Before the Federal Communications Commission Washington, DC 20554

In the Matter of)	
	Ć	
Amendment of Part 68 of the)	CC Docket No. 96-28
Commission's Rules)	
)	
	j

ERRATA

On August 22, 1997, the Commission released a Report and Order, in this proceeding, CC Docket No. 96-28, FCC 97-270, *Amendment of Part 68*, 12 FCC Rcd 19218 (1997). The final rules in the Report and Order are hereby amended to conform the rules to the text of the Report and Order.

FIGURE 68.310 (f)
REQUIRED TERMINATION FOR CONNECTIONS TO NON-REGISTERED EQUIPMENT

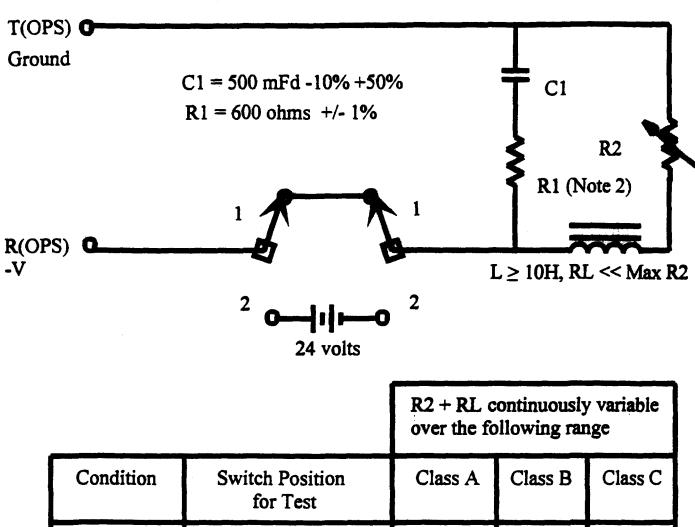
- 20. In §63.310, paragraphs (b)(3) and (b)(4) references to Figure 68.310(b) are revised to read "Figure 68.310(f)".
- 21. In §63.310, the last sentence of paragraph (b)(5) is revised to read: "The termination for all ports other than the particular one whose transverse balance coefficient is being measured shall have a metallic impedance of 600 ohms, and a longitudinal impedance of 500 ohms. Figure 68.310(c) shows this termination."
- 22. In §63.310, Figure 68.310-2 is revised to "Figure 68.310(f)".

Z - Selected so that the reflected impedance at tip and ring is 600 Ω , 135 Ω , or 100 Ω depending on the service type of EUT

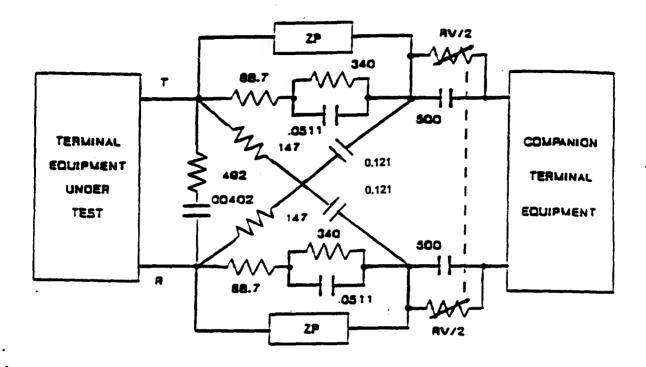
- 3. Section 68.3 is revised by removing figure $68.3 \, (m)$, and correcting figures $68.3 \, (f)$ and $68.3 \, (i)$.
- 4. In §68.3, reference to "figure $68.3 \, (m)$ " in the definition "PSDS Type II Analog Mode Loop Simulator Circuit" is revised to read "figure $68.3 \, (k)$ ".
- interfaces" paragraphs(d), (e) and (f)" are revised to read "paragraphs (c), (d) and (e)".

- (a) ****
- (b) ****
- (7) ****
- (i) ****
- (ii) ****
- (A) ****
- (B) ****
- (C) Except for Class A OPS interfaces, the dc current into the OPS line simulator circuit must be at least 20 mA for the following conditions (see Figure 68.3(f)):

Condition	Switch Position for Test	Class A	Class B	Class C
1	1	up to 200 ohms	up to 800 ohms	up to 1800 ohms
2	2	N.A.	200 to 2300 ohms	900 to 3300 ohms

The minimum current for all resistance ranges shall be 16 ma.

Notes: (1) Means shall be used to generate, at the point of tip (T OPS) and ring (R OPS) connections to the PBX, the range of resistance and impedance which are employed by the illustrative circuit depicted above.

⁽²⁾ In the transverse balance limitations, Section 68.310, the use of the dc portion of the loop simulator is specified. In such cases R1 and C1 shall be removed.

⁽³⁾ Tests for compliance may be made with either R1 = 600 ohms or R1 replaced by the alternative termination specified in Figure 68.3(g).
